NDI ID PA-00945  
PA DER 9-156

LAKE CAROLINE DAM

PHASE I INSPECTION REPORT,  
NATIONAL DAM INSPECTION PROGRAM.

FEBRUARY 1981

PROJECT Lake Caroline Dam, Field Observation Profile	SHEET 11B	BY R. R. B.	DATE 12/23/80	JOB NO. 1841-014
---	--------------	----------------	------------------	---------------------

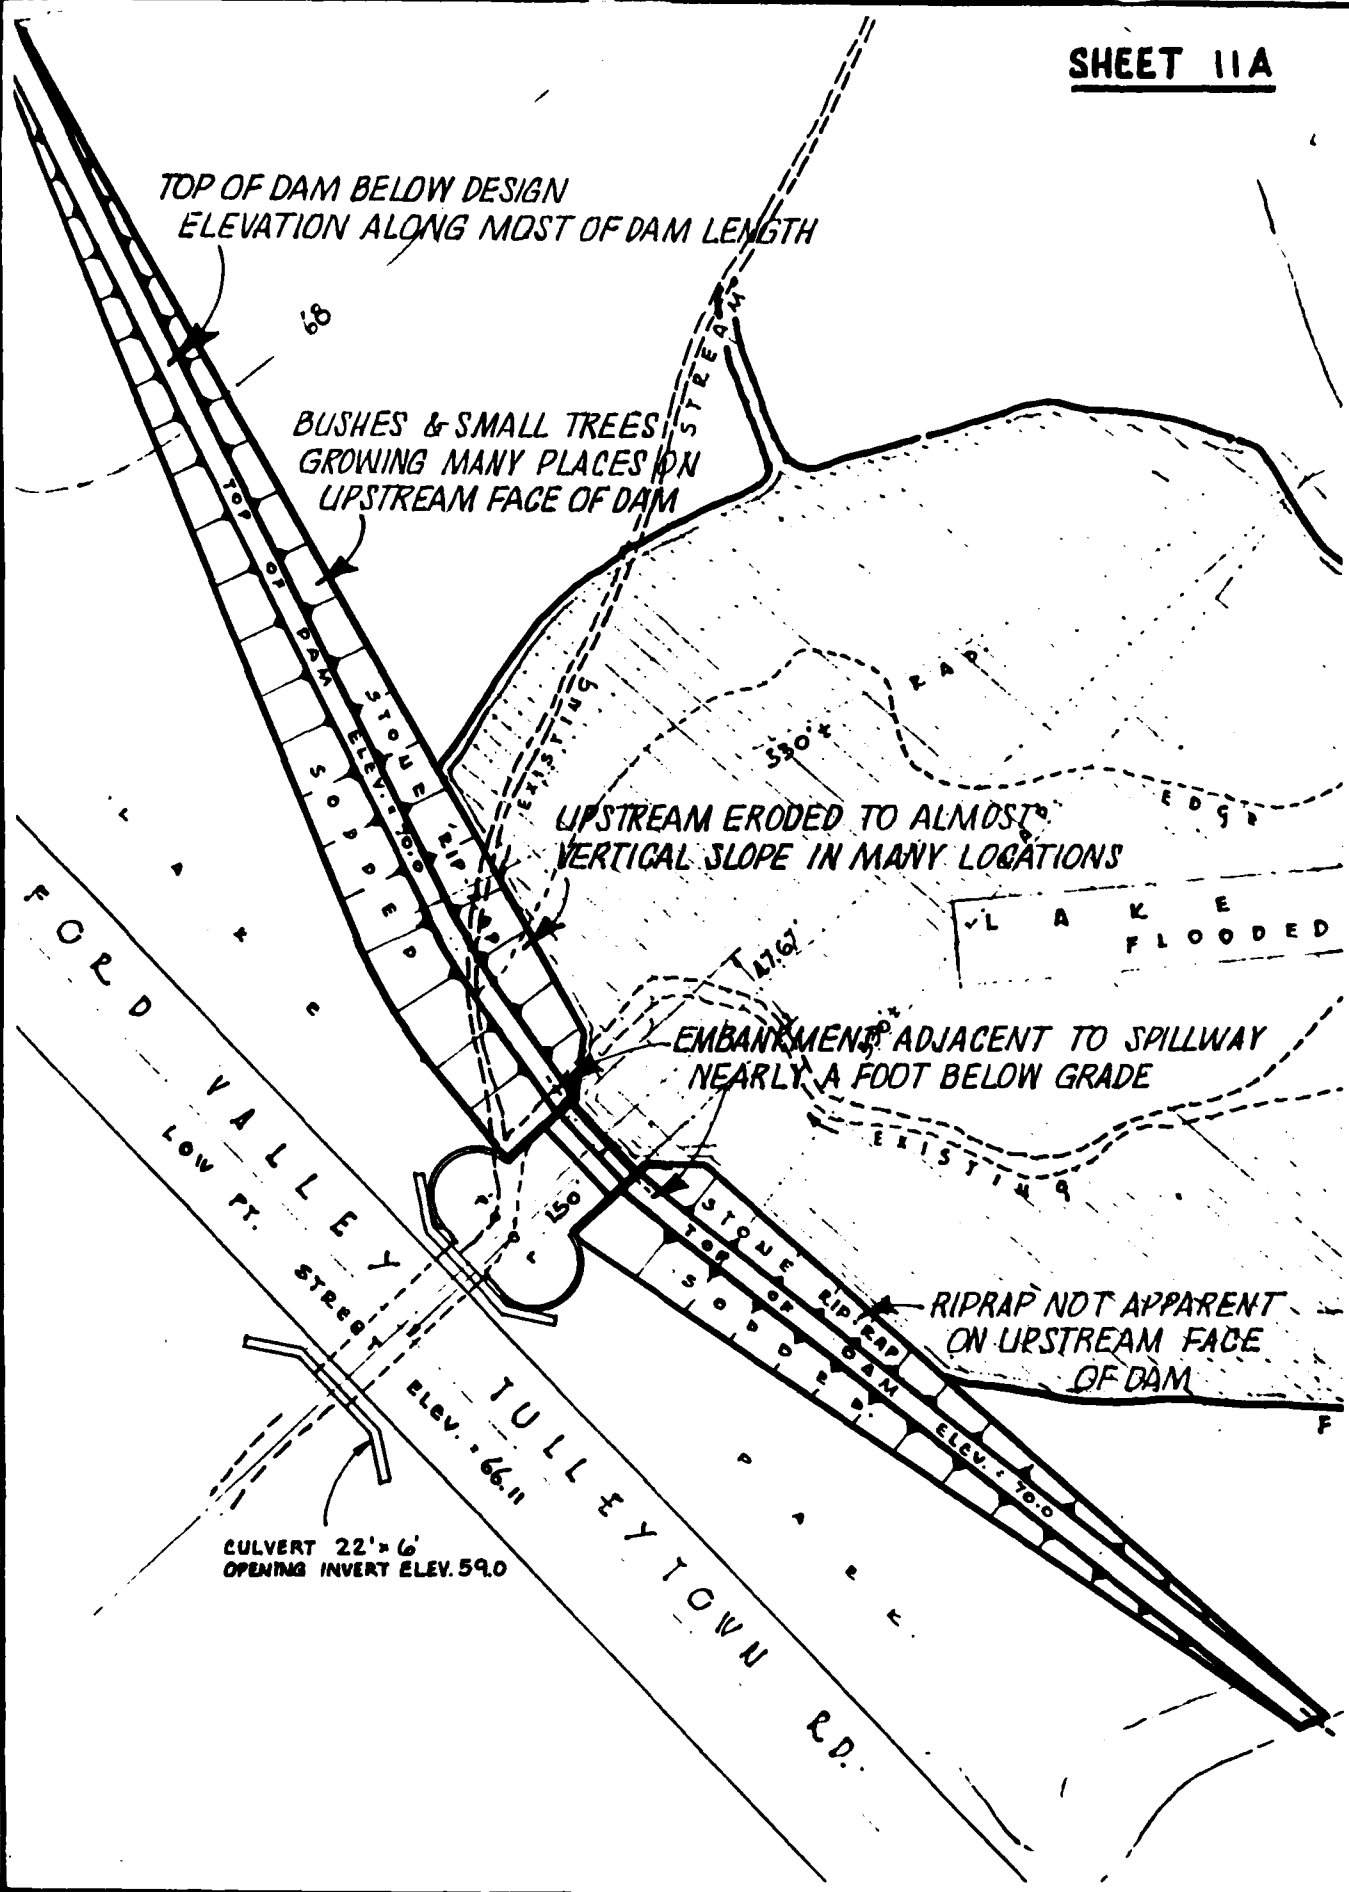
TOP OF DAM BELOW DESIGN  
ELEVATION ALONG MOST OF DAM LENGTH

BUSHES & SMALL TREES  
GROWING MANY PLACES ON  
UPSTREAM FACE OF DAM

UPSTREAM ERODED TO ALMOST  
VERTICAL SLOPE IN MANY LOCATIONS

EMBANKMENT ADJACENT TO SPILLWAY  
NEARLY A FOOT BELOW GRADE

RIPRAP NOT APPARENT  
ON UPSTREAM FACE  
OF DAM

CULVERT 22' x 6'  
OPENING INVERT ELEV. 59.0
